Re: Implementation of the Stanley Park Cycling Plan (March 27, 2012)

HUB Cycling is a charitable organization that works to make cycling better through education, events and collaboration. We are Metro Vancouver's leader in making cycling an attractive choice for everyone. We are writing to comment on the update recently forwarded to us entitled Stanley Park Cycling Plan Implementation Update – Board Briefing Memo (March 22, 2019), attached here.

SUBJECT : **Stanley Park Cycling Plan Implementation Update – Board Briefing Memo**

Figure 8 - Coal Harbour Gateway Entrance Node (SPCP 12a)

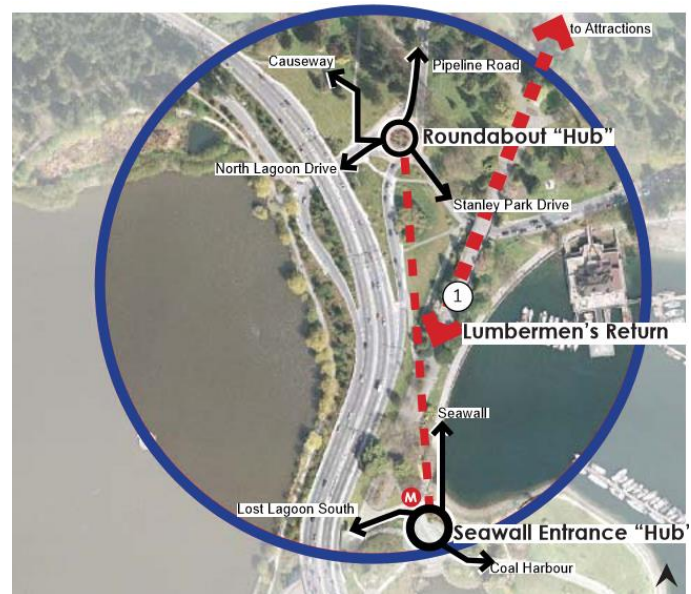
There is also a dangerous implementation of a shared multi use path here, shown in Figure 7. This path is too narrow to meet safety codes for bidirectional pedestrian and unidirectional shared cycling use. We recommend either a pedestrian Do Not Enter sign at each end, or removal of the bike stencils and a return to pedestrian only use. The painting of the crosswalk at the south end of the path appears to indicate that it is intended as a pedestrian route. The connections that were recommended in SPCP 12a are shown in figure 8. We recommend a full implementation of the Gateway Node. This will include connections between the two hubs. We do not agree that this recommendation has been implemented, as there is no way through to the Roundabout Hub. These connections were one of the highest priority recommendations by Park Board staff for early implementation in 2012.

Figure 9 - Planned Park Board 2019 Cycling and Pedestrian Improvements Map

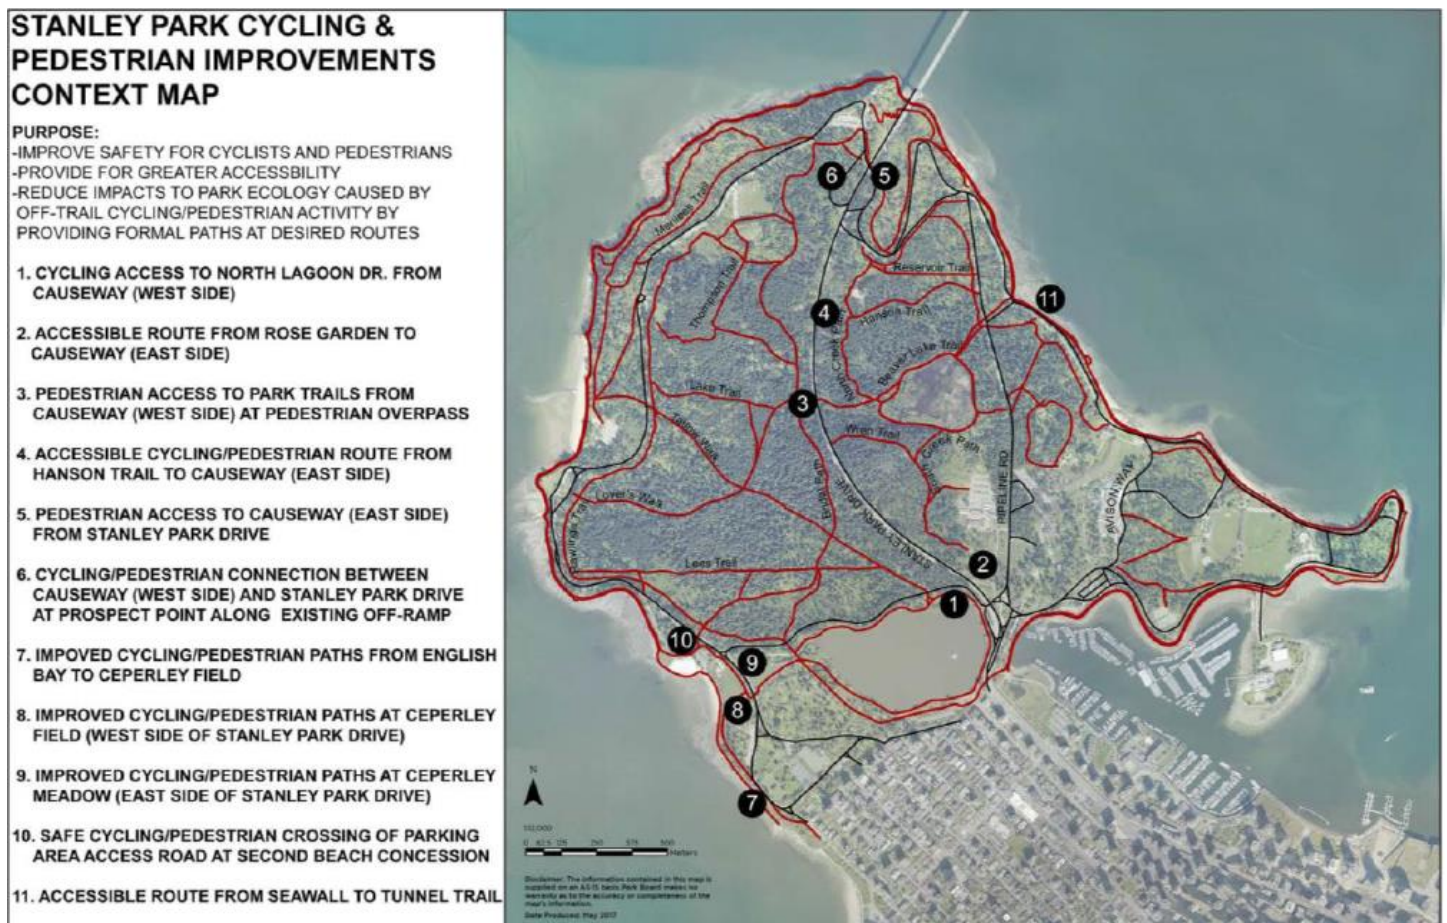
Our specific comments and concerns over the eleven planned improvements are as follows (the numbers match the items on the map in Figure 9):

- 1) The cycling link from the west side of the Causeway to North Lagoon Drive (SPCP 8b) is much needed and we strongly support implementing one. Our concerns are that as originally conceived in the 2012 SPCP, a new path would be constructed through the vegetation from the Causeway to North Lagoon Drive (Figure 10) It would then deliver people on bikes out onto a roadway, in a corner. This is unsafe, and unnecessary, and we recommend against it. There is an existing paved path that is not designated as a cycling path. If so designated, this path would safely replace new construction, be cheaper, be safer, and result in less impact to the ecosystem. It is shown as a dotted white line in Figure 10, and from the north end looking south, in Figure 11. It requires bike stencils, a No Walking sign, and consideration of the connection at the south end (likely involving a curb ramp and green paint). This recommendation has been previously raised with Park Board staff, and we were advised at that time that the path could not be change over from pedestrian use as people may want to walk there. This makes no sense to us, as the path does not serve any pedestrian purpose, and in fact creates a safety risk for people walking if they use it to access the west side Causeway cycle path. When the west side Causeway path was converted to bike use only by MoTI in 2016, any need for a pedestrian sidewalk to that bike path was eliminated. Hopefully, the plans for this year do not involve building a new path but they should address the safety issues described. We look forward to reviewing the design drawings.

- 2) The 2012 SPCP did not recommend this improvement. There is an existing pathway from the Rose Gardens to the east side Causeway path. It is paved, but narrow. It is currently designated as a shared walk/bike path, but is not marked at the entrance to it, so users are often unaware that they make cycle here. The planned improvement was explained to us by Park Staff as an Accessibility Improvement, made necessary by the steep slope up to the causeway path for people with limited mobility. We asked about cycling connectivity and were advised that people on bikes were not being considered for the intended use of this path. Continued use of this path by people on bikes was envisioned as part of the 2012 SPCP. If in fact the path is restricted in future to not allow people on bikes, then that is a significant issue. The only other way to access the east side Causeway paths is from the Georgia Street off ramp, along a narrow and unprotected sidewalk. Implementation of the

- 3) The 2012 SPCP recommended construction of a path from the west side sidewalk to the pedestrian bridge at this location. Given the conversion of the west side sidewalk to bike only use by MoTI in 2016, this is no longer a valid recommendation. It may in fact lead to more pedestrians finding themselves on the bike path, creating a safety risk for users of both modes. We recommend that work be ceased on this item.

- 4) The 2012 SPCP did not include a recommendation for the construction of a new trail from Hanson Trail to the east side Causeway shared path. There is a route along Hanson Trail north to reach the east side Causeway. Although Hanson Trail has been designated as a multi-use trail in the 2012 SPCP, it is uncomfortable and unsafe for people using bikes and wheelchairs, due to the steep hill and poor surface treatment. Resolving this issue would be a much better use of resources than constructing a new trail connector. Due to its current state, we discourage its use. We recommend that work be ceased on this item. This item is noted as being complex, and subject to delays, so it appears there is time to stop and reconsider.

- 5) The 2012 SPCP recommended the construction of the multi-use path from Park Drive to east side Causeway. The current plan appears to be for a pedestrian path, which does not meet the recommendation of SPCP 18a. There is no functional benefit to a cycling path at this location given other nearby access points. If there is a requirement for a pedestrian path from the overpass sidewalk, that is understood, but we do not consider it to be part of implementing the 2012 SPCP and recommend that the funds budgeted associated with the 2012 SPCP not be applied to this item.

- 6) The 2012 SPCP did not recommend this connection, a route alongside the southbound Causeway exit road to Park Drive. We strongly support creating this link, which has become an even more obvious gap with the completion of the separated paths along the Causeway. Unfortunately, Park Board staff advised us that there was no plan for a safe and protected bike route, but rather the creation of a pedestrian sidewalk, and that bikes would be required to share the roadway with vehicles exiting from the Causeway. A traffic study is required here to determine the best solution. As this item is reportedly delayed due to complexity, it appears that there is time to engage Vancouver City transportation engineers in designing a safe connection, and we recommend that this be done. This is an important link, and it needs to be a safe and protected one that is comfortable for people of all ages and abilities, since the paths leading to this point are protected from vehicle traffic.

- 7) The 2012 SPCP recommended the construction of a new path at this location, and we support this initiative, for the safety and comfort of people both walking and cycling. It is important that the new paths be sufficiently wide, and physically separated for users of different modes, as recommended in the 2012 SPCP. The crosswalk should be raised for safety of people walking and cycling. It is also important that the path crossings be marked

- 8) The 2012 SPCP recommended two alternatives for improved pedestrian access at the Ceperley Park tunnel. The option chosen requires that people cycling detour to the north and then double back, and so provides no functional benefit. In fact, it takes a direct and safe 80 m cycling connection on a protected off-street path, and increases it to 380 m, while adding in a crossing of a busy roadway. We are glad to see that this option includes a raised crossing and recommend that this crossing have separate crossing lanes for people walking and people on bikes, to reduce conflicts. While these items reduce the safety for people on bikes, the combination package of items 8, 9, and 10 does provide overall value for people walking, and for that reason we support it. We are concerned with the details of the design and look forward to reviewing the design drawings. It will be necessary that these three items be treated as a single item in terms of implementation timing. We look forward to reviewing the design drawings for these three items.

- 9) Comments as per item 8
- 10) Comments as per item 8
- 11) The 2012 SPCP recommended the creation of an accessible ramp from the seawall at this location, and connection through to a return route to the Coal Harbour entrance hub. We strongly support the implementation of a return route, to reduce congestion on Seawall paths and reduce the incidences of people cycling in the wrong direction on the seawall. The return route implementation is more important than this specific ramp and depending on which return route is selected for implementation first, the requirements for this ramp could vary. The 2012 SPCP noted that the Lumbermen's return route was nominated by Park Board staff as the preferred top priority. If this is constructed, a ramp could be combined with the recommended on-road protected lane bypass of the Kid's Water Park (SPCP 7c) We understand that this return route faces complications related to archeological issues. We recommend that the prioritization be revisited, as recommended in the 2012 SPCP if in fact delays were encountered with it, and that the Pipeline Road return route be considered for priority implementation. This largely avoids issues related to archeological finds, reducing vegetation removal, and adding impermeable surfaces, as it uses existing pavement along Pipeline Road. This return route could be implemented relatively quickly, and at a much lower cost, than the alternatives. We recommend that consultation take place on these return route decisions, as they will then inform the decisions on where a ramp is required. We note that this item has been delayed due to requiring additional design work, and so there is perhaps time for a discussion on the priority return route selection.
